**SECTION 96(1A) - MODIFICATION APPLICATION TO SSD 6840
ST VINCENT'S PRIVATE HOSPITAL SYDNEY**

On behalf of St Vincent's Private Hospital Sydney (SVPHS), we hereby submit an application pursuant to section 96(1A) of the *Environmental Planning and Assessment Act, 1979* (EP&A Act) to modify Development Consent SSD 6840 relating to the approval of the East Wing building and the SVPHS high-rise building located within the St Vincent's Hospital campus (the site).

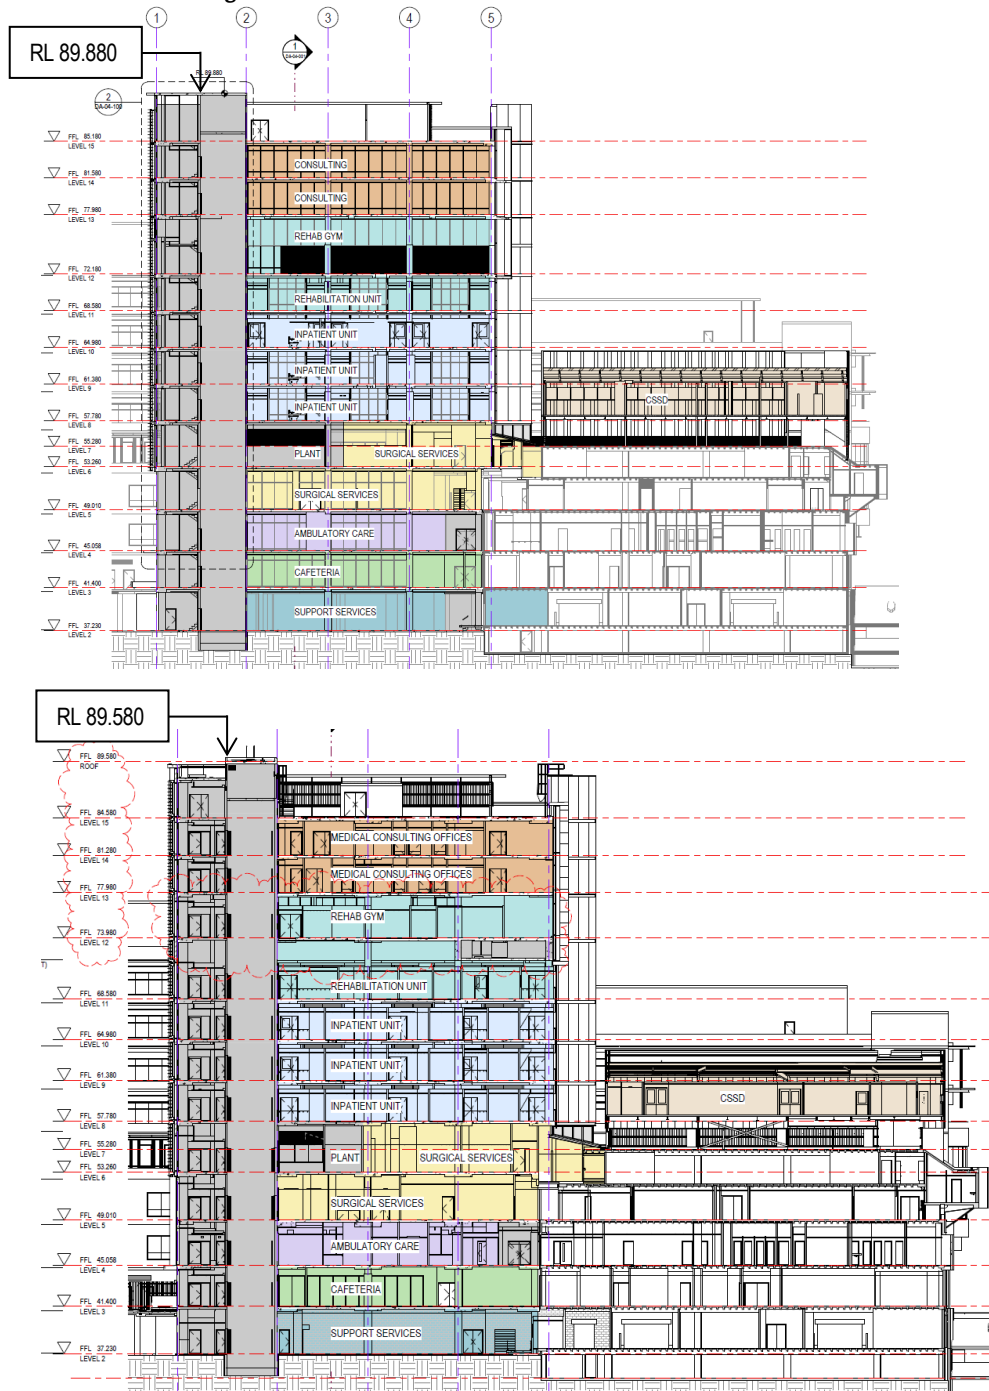
Amendments to the floor to floor heights are required to accommodate the aforementioned split level on Level 12 and the previously approved hydrotherapy pool. Whilst increases to the floor to floor heights are proposed on Level 12, those on Levels 14 and 15 have been reduced to maintain consistency with the building's approved height. The proposed changes are illustrated below in **Figure 2** and are detailed in **Table 2**.

Further, a slight amendment is proposed to the building height where the lift overrun is located on the north eastern section of the East Wing building. The amendment results in a decrease in the building height from 48.48m (RL 89.880) to 48.18m (RL 89.580), resulting in a 300mm reduction in height.

Level	Use	Approved (RL)	Proposed (RL)	Change (m)
Level 12	Plant / Rehab Gym / Hydrotherapy Pool	72.180	73.980	+1.8
Level 13	Consulting Suites	77.980	77.980	0
Level 14	Consulting Suites	81.580	81.280	-0.3
Level 15	Plant / Lobby / Meeting Room	85.180	84.58	-0.6
